TECHNICAL MEMORANDUM

To: **Emily Anderson, Alaska Program Director, Wild Salmon Center**

From: **André Sobolewski, Clear Coast Consulting, Inc**

Subject: **Review of water treatment plants proposed in FEIS for Pebble Project**

Figure 1. Water Treatment Plant #2 - Operations Phase. Taken from USACoE FEIS Appendix N – Project Description

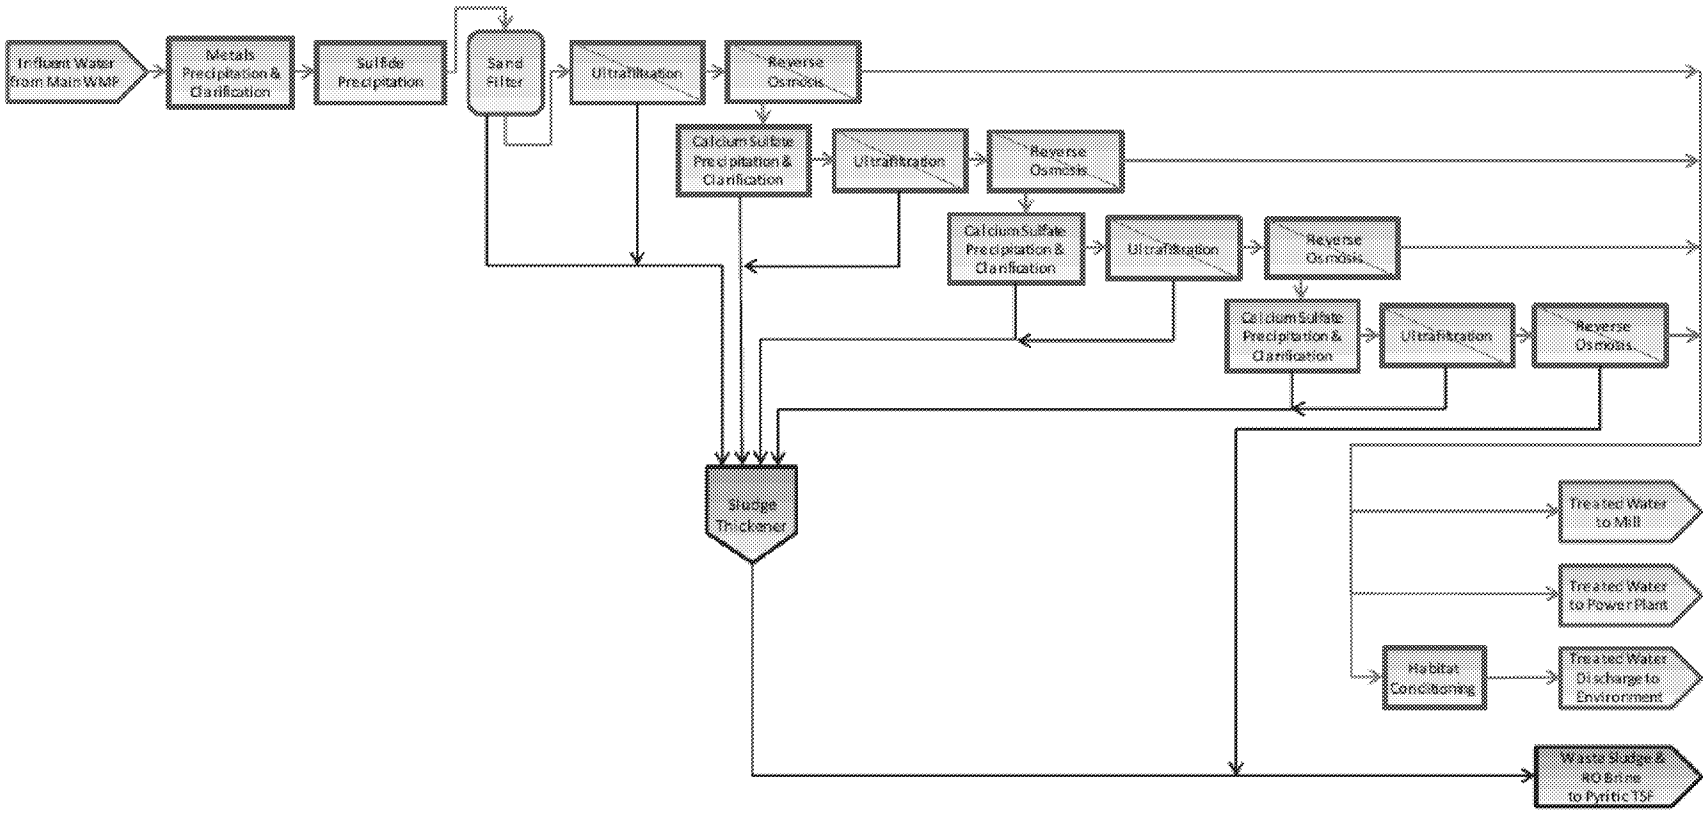
For this analysis, I used the proposed WTP #2 for mine operations (Figure 1), as it is among the most comprehensive WTP proposed for this project (WTP #3 also comprises an evaporator/crystallizer unit). This treatment system shares many components with WTP #1 and WTP #3 and any analysis of WTP #2 will readily apply to these other treatment plants.

The first step in the treatment process – permanganate oxidation and ferrihydrite precipitation – is effective in removing arsenic and manganese and is widely used. Depending on treatment conditions (pH, ORP), molybdenum will also be removed to acceptable levels, as evident by the treatment plant at the closed Brenda Mine (Aubé and Stroiazzo, 2000) and at Coldelco's El Teniente Mine (Aubé and Vergara, 2010).

Permanganate oxidation, followed by ferrihydrite precipitation is reported to remove selenium (RFI 021e Addendum, 2019), but this is incorrect. Ferrihydrite precipitate the *partially-reduced* selenite (SeO_3^{2-}), not the *full oxidized* selenate (SeO_4^{2-}). Thus, an initial reductive step is required to reduce the unreactive selenate to selenite, like the addition of zinc dust (Alberta Environment, 2005), and to remove it via iron co-precipitation. The latter reaction is effective in decreasing high inflow concentrations of selenium, but it can only decrease its levels to ~0.020 mg/L. An additional step is necessary to decrease its concentration < 0.005 mg/L.

Iron co-precipitation can remove several metals; however, their concentrations will not be decreased low enough to meet stringent water quality criteria (MEND, 2014). A High-Density Sludge (HDS) system is required to decrease metals to trace levels, but this is not what is proposed at Pebble. Therefore, additional treatment will be required to decrease the concentration of most metals to levels acceptable for discharge.

Selenium is proposed to be removed as a selenide via precipitation with sulfide. This reaction is technically possible and has been demonstrated in the laboratory, but it requires conditions that are not met in a mining environment (low redox potential, high sulfide concentrations, etc). To my knowledge, this process has never been used in a commercial application, and certainly never at a large-scale mining operation. Several specialists who know or investigated this process[1] have confirmed that it is impractical for selenium removal from mine water.

In the absence of chemical precipitation, selenium will be removed in the WTP by membrane filtration, either via nanofiltration or reverse osmosis. Given that selenium-containing brine generated by membrane filtration will be discharged into the Pyritic TSF, there is a concern that its concentration will build up in mine water because WTP #2 → Brine → Pyritic TSF → Main WMP → WTP #2 is a closed-loop circuit. This concern was acknowledged by Pebble and was analyzed through a water balance and water chemistry model (Knight Piésold, 2019). I reviewed this model.
